San Onofre Nuclear Generating Station Unit 2 and Unit 3 GSI-191 Generic Letter 2004-02 Corrective Actions Audit Report

Figure 3.1 Isometric View of Alion Test Tank with SONGS Prototype Strainer Installed

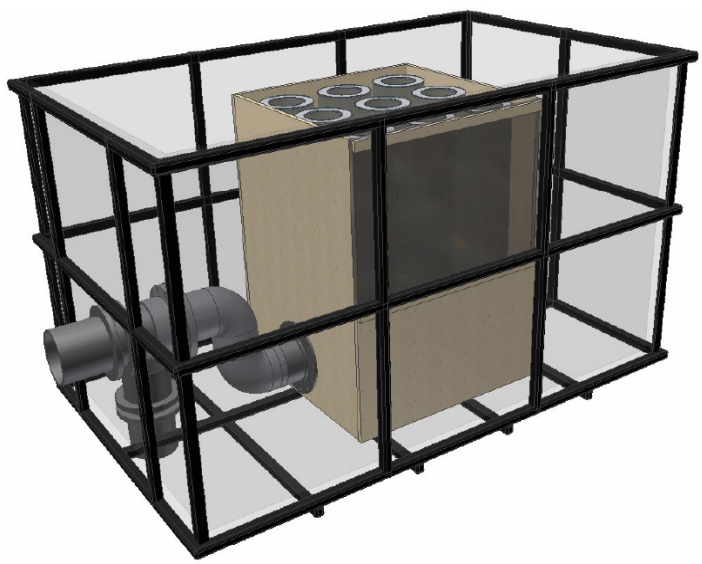
The licensee had not addressed the potential head loss change from RMI debris entering the interstitial volume of the sump pit. Since the staff has not seen sufficient evidence to support the assumption that excluding RMI from head loss testingwould result in conservative head loss measurement, the staff designates this issue as **Open Item 8**.
